ADDENDUM No. Two (2)

IFB No. 2019-183

CONSTRUCTION, REROOF COLLIN COUNTY 920 E. PARK BLVD., PLANO

ADDENDUM NUMBER 1

7 Downspout and Splashbl
Scale: 1 1/2" = 1' - 0"

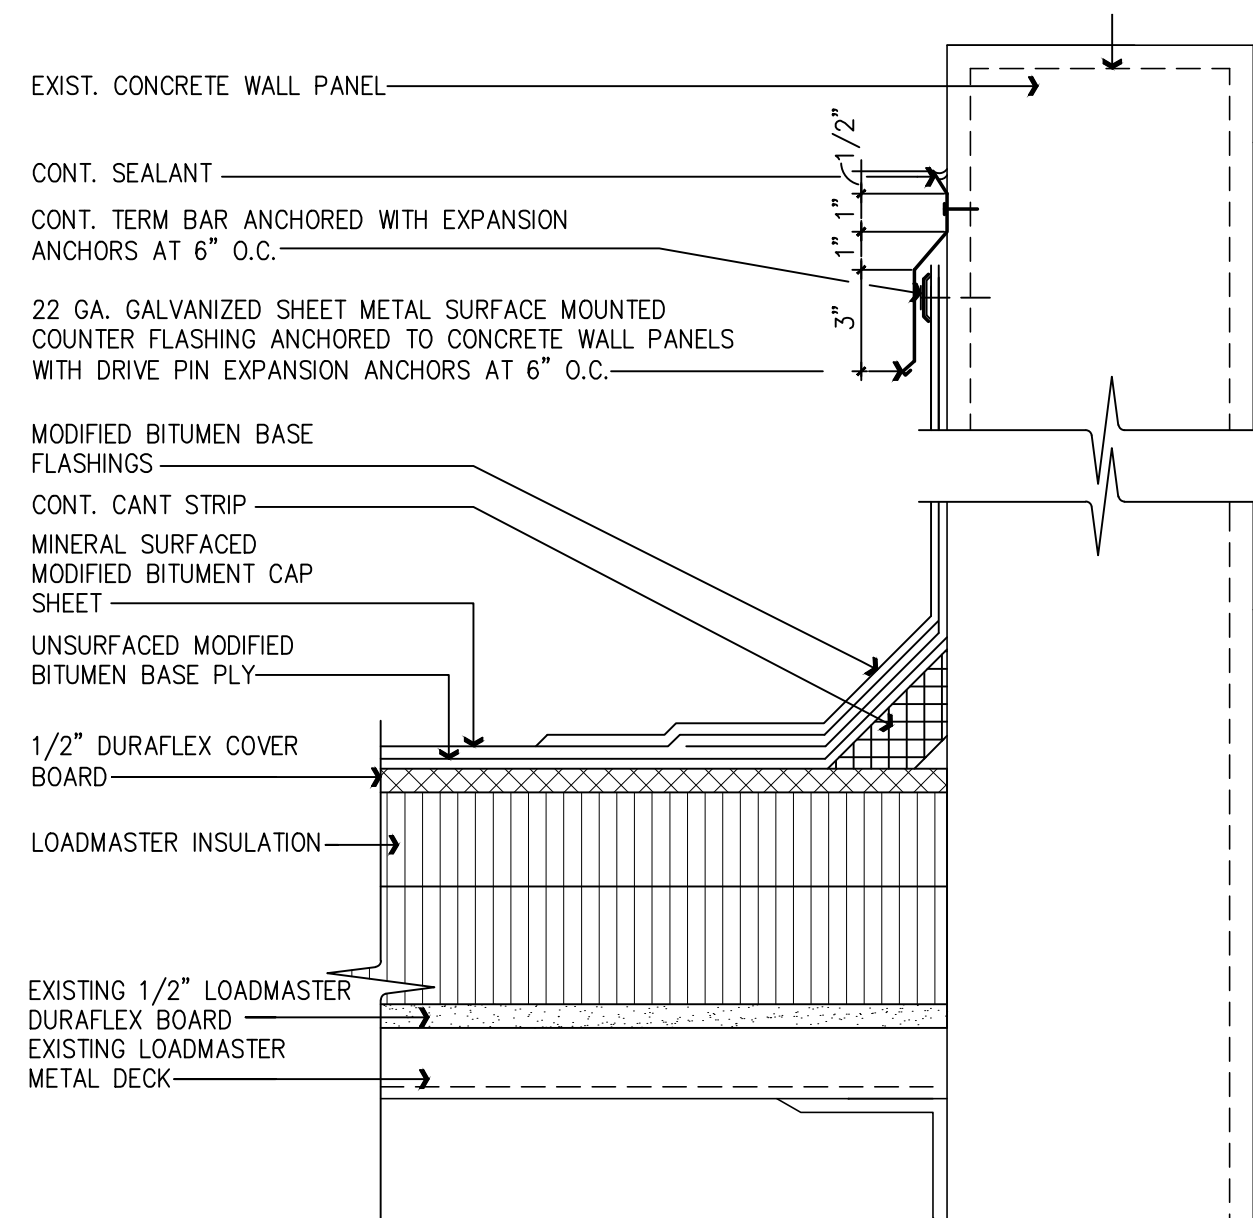
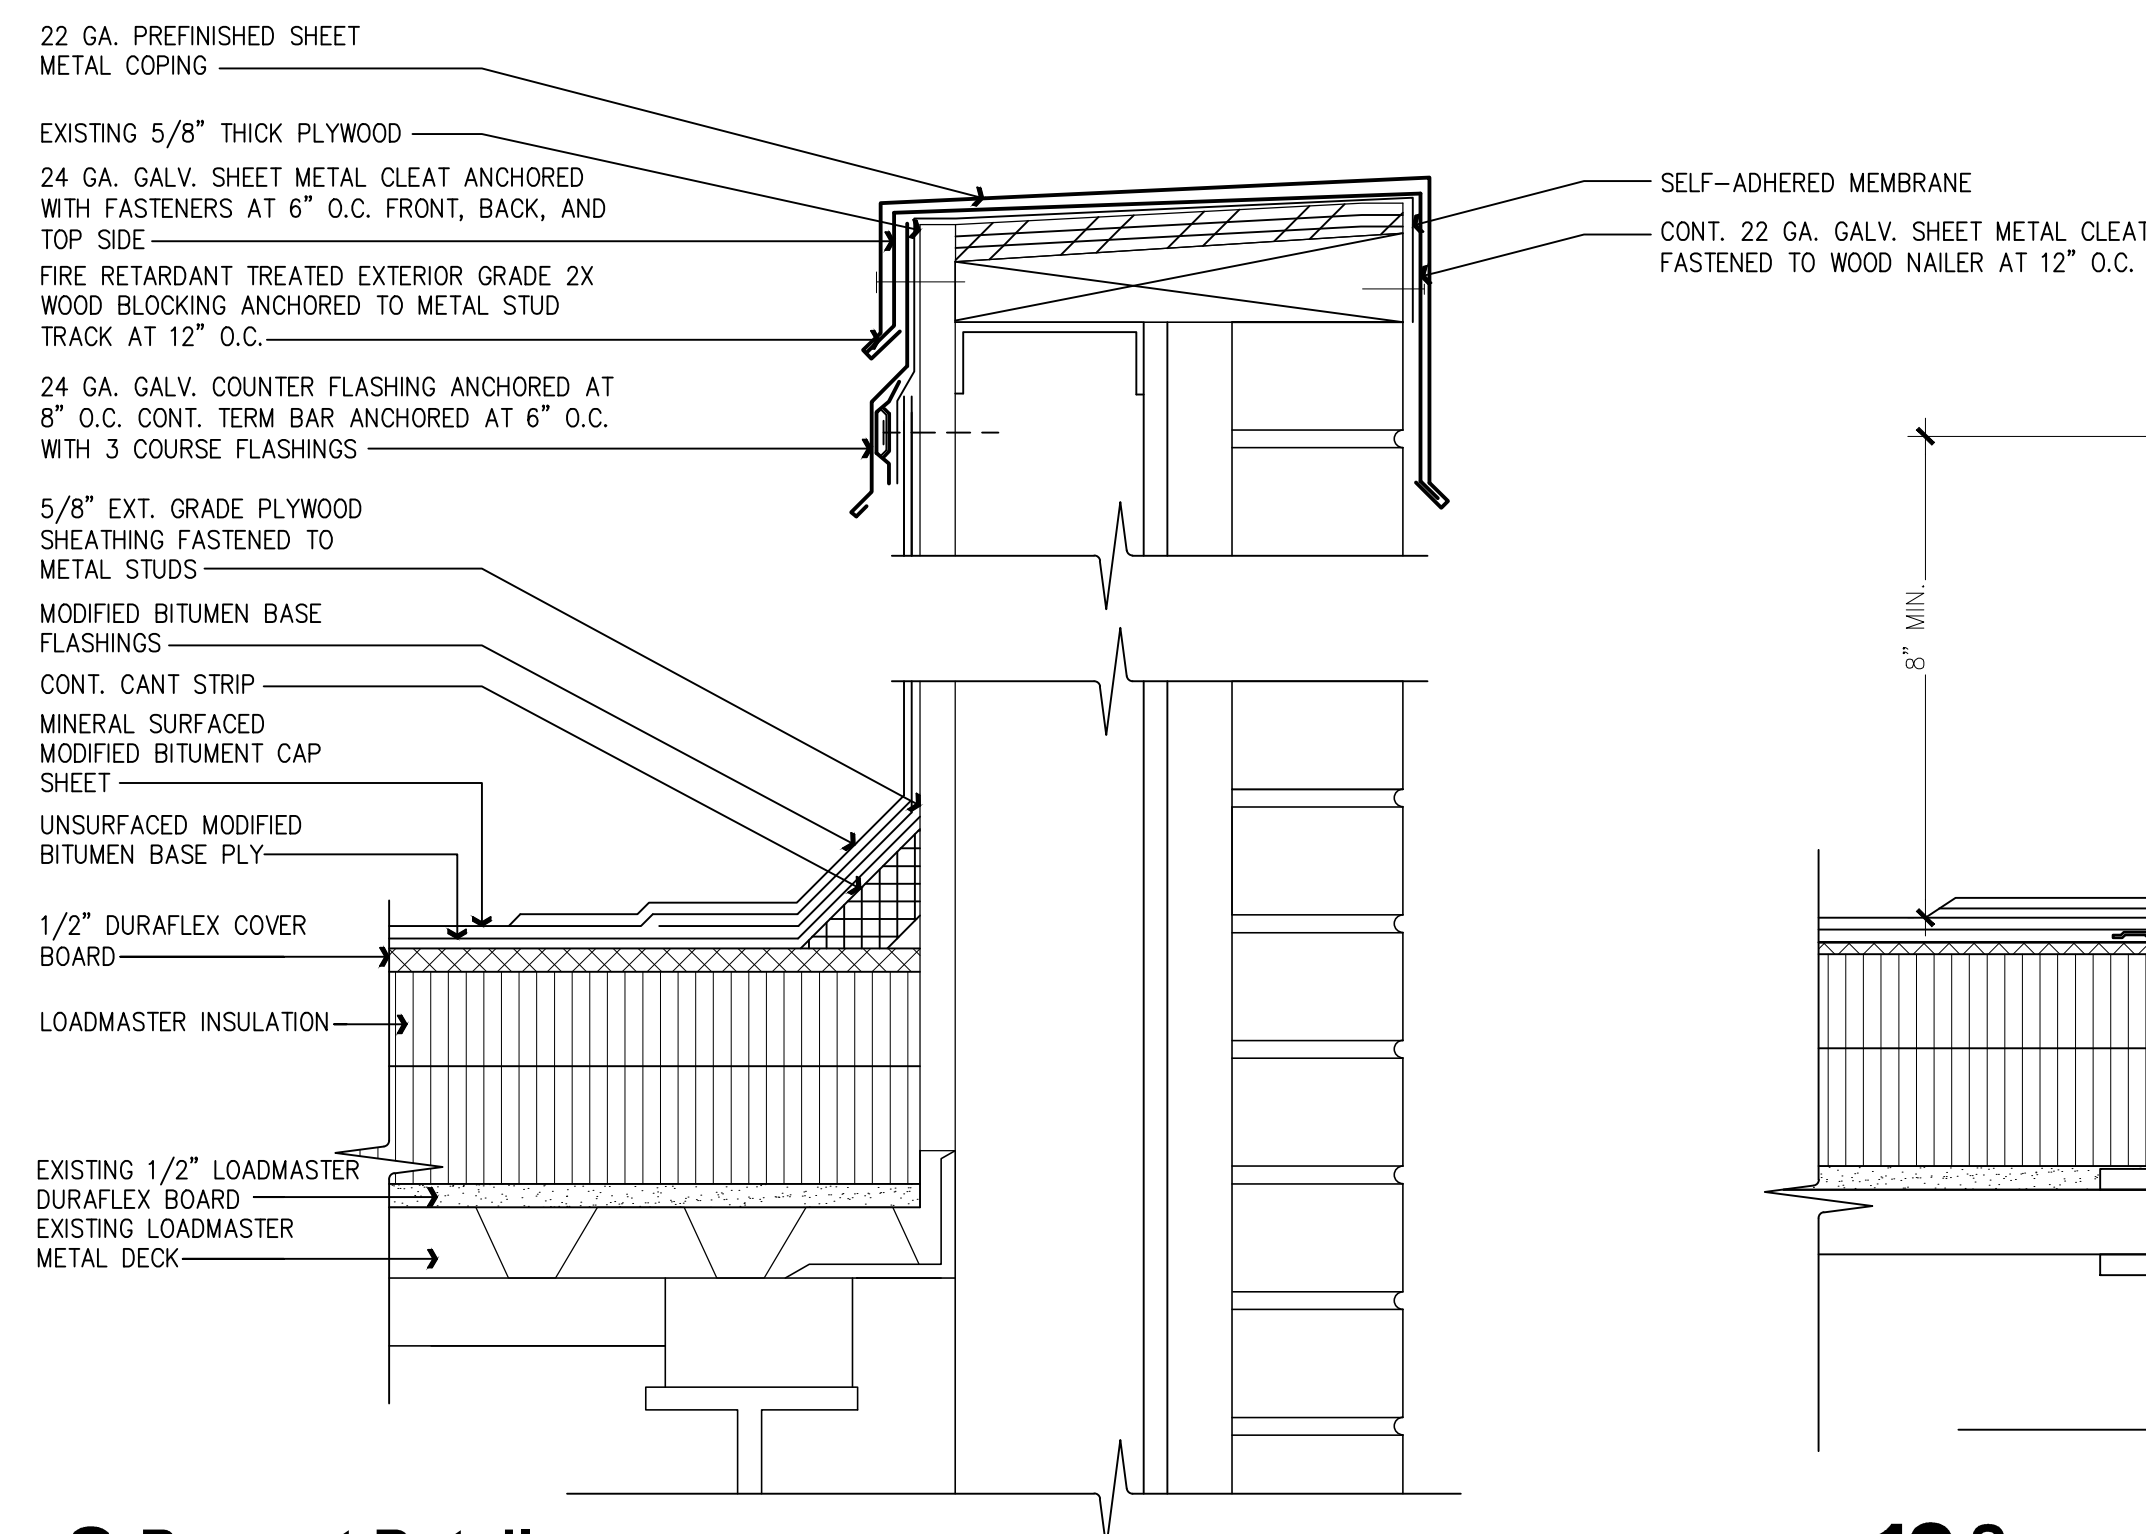
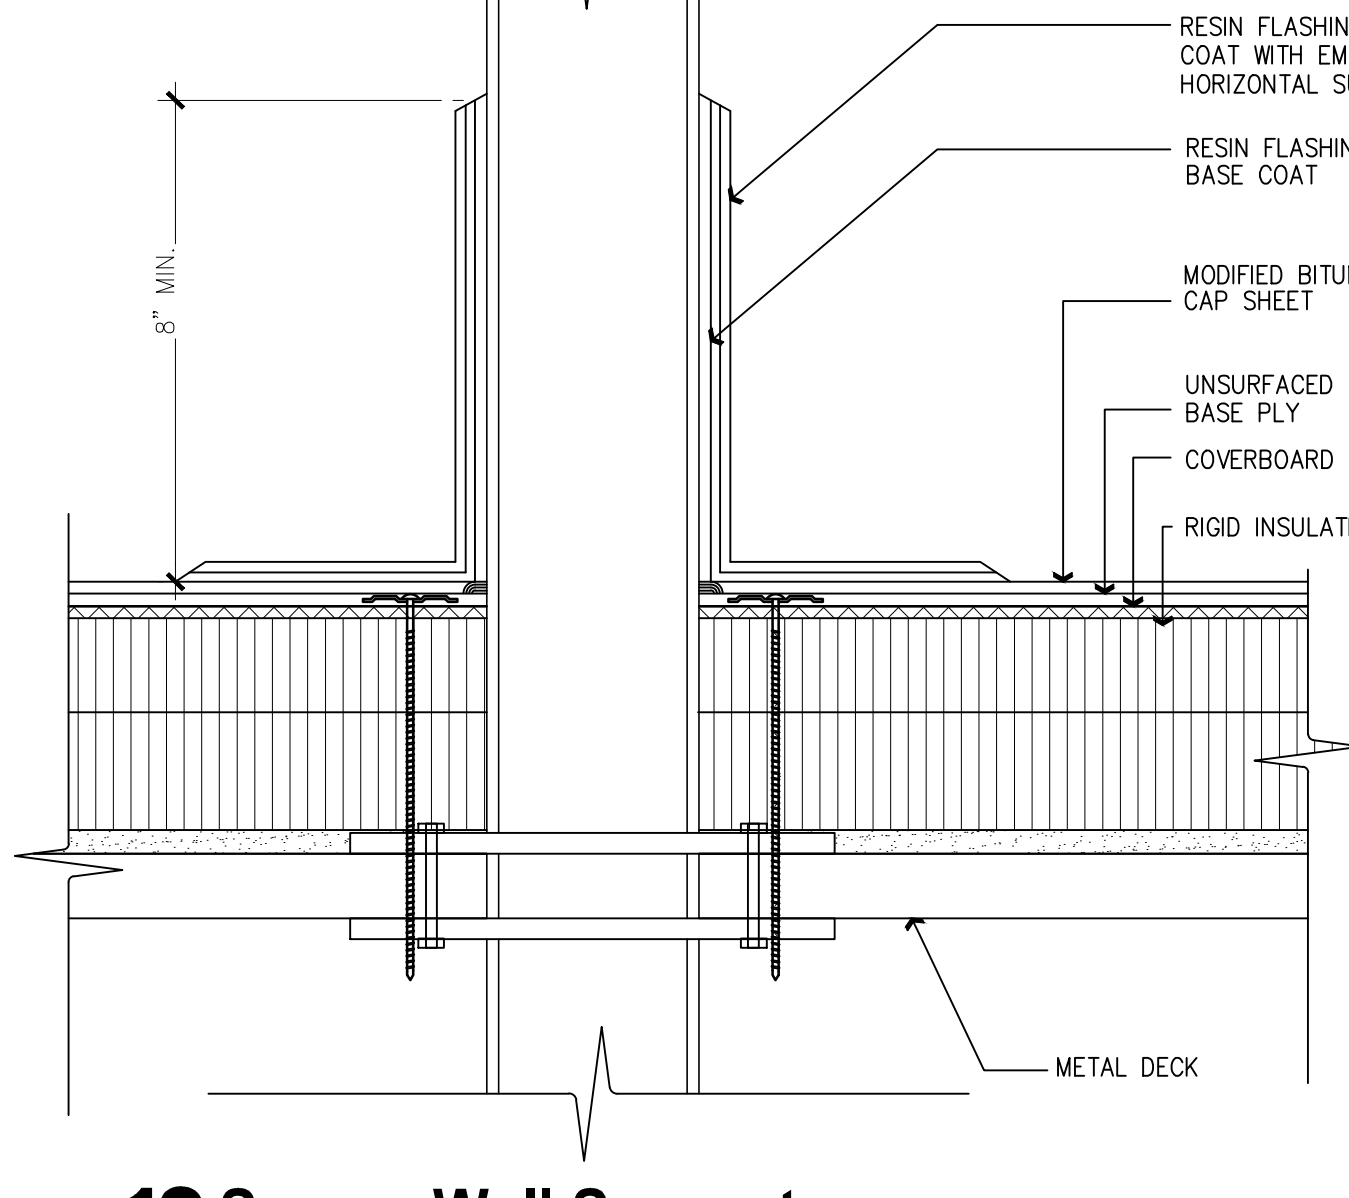
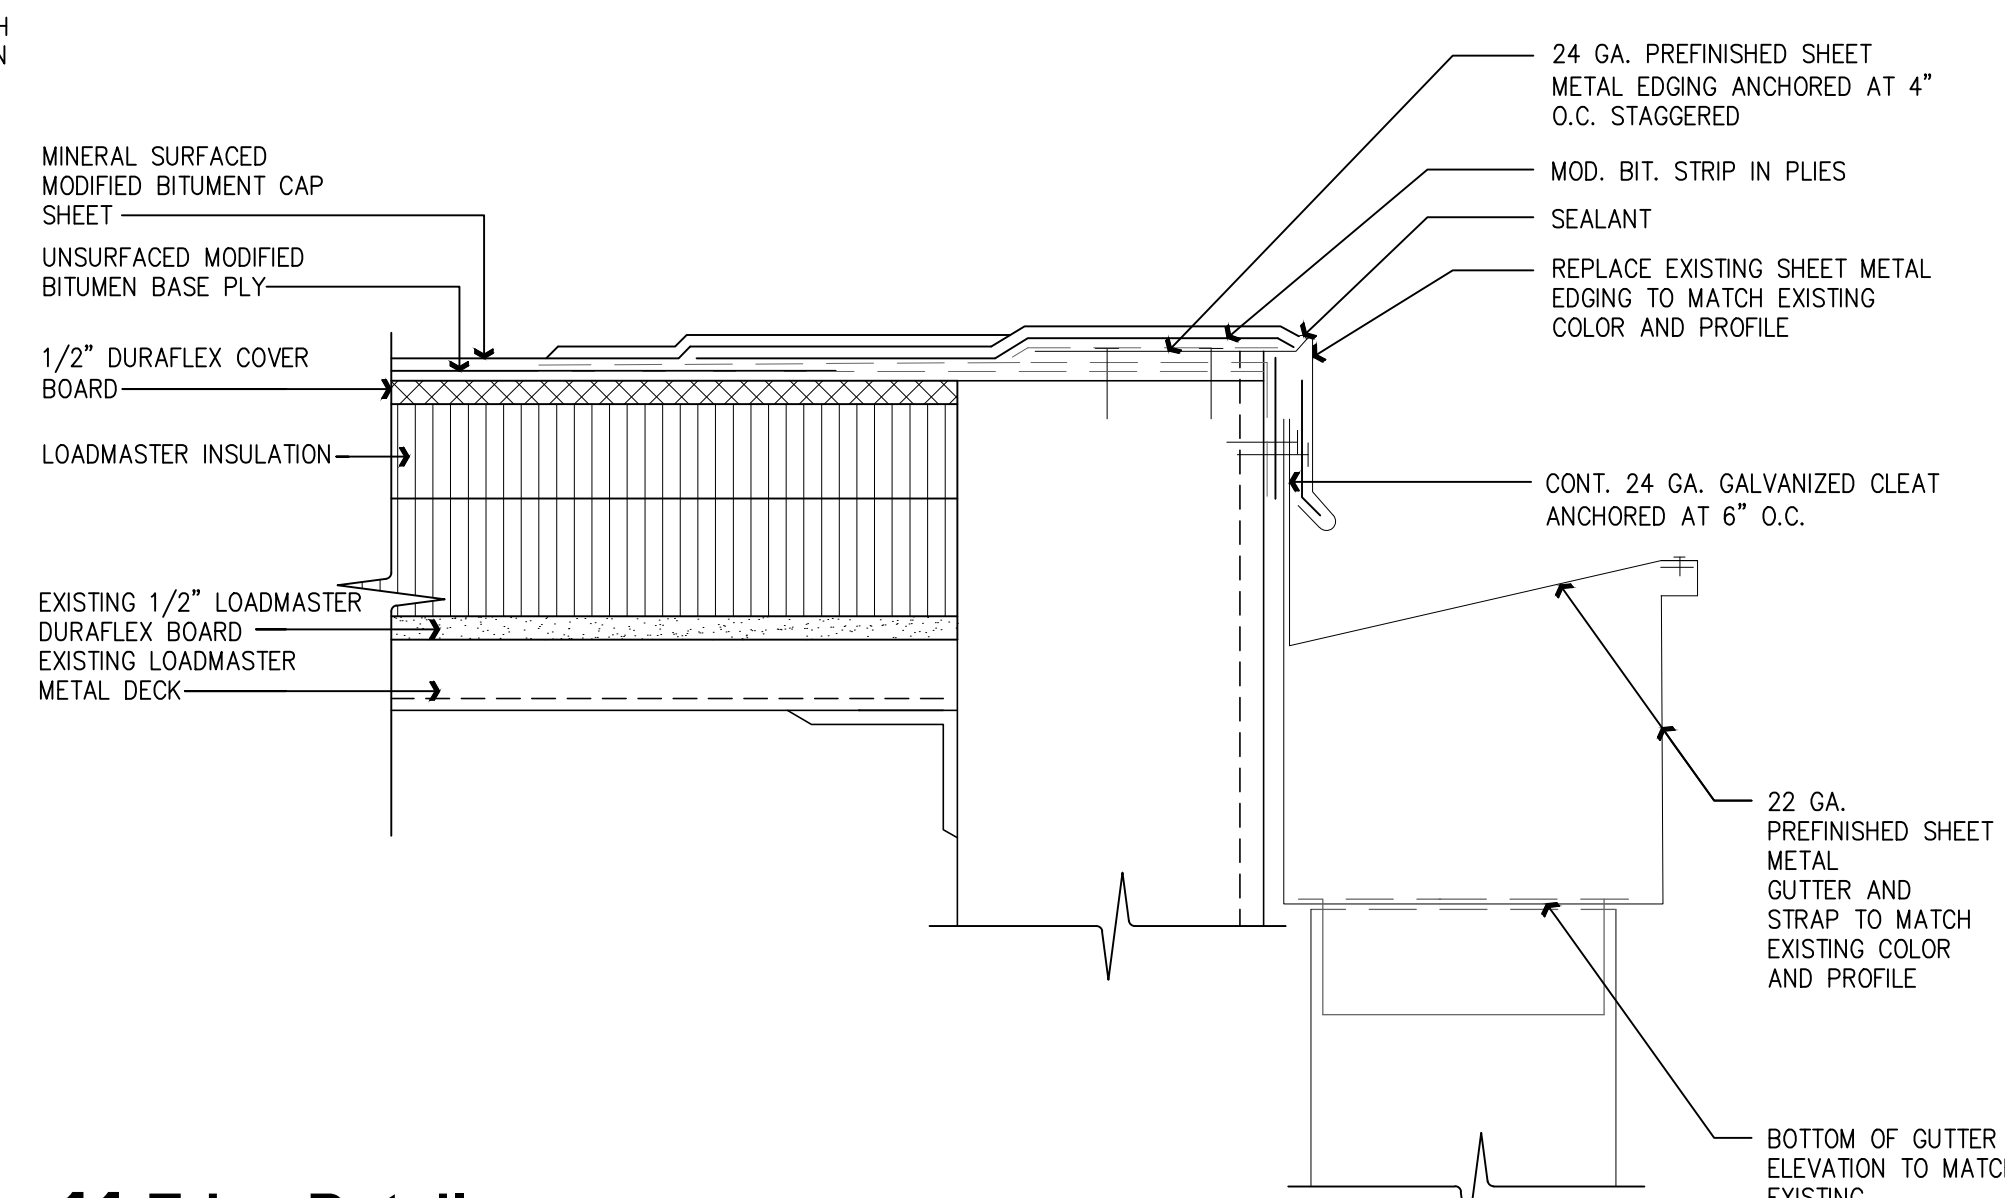
1. The attached revised Sheets R1.0, R1.1 and R2.1 replace the original Sheets R1.0, R1.1 and R2.1 with the changes associated with the Addendum being noted and clouded.
2. The attached Sheet R2.2 is added to the Contract Documents and includes information related to where a dumpster can be positioned, where roofing materials can be staged and where the sky track can be parked.
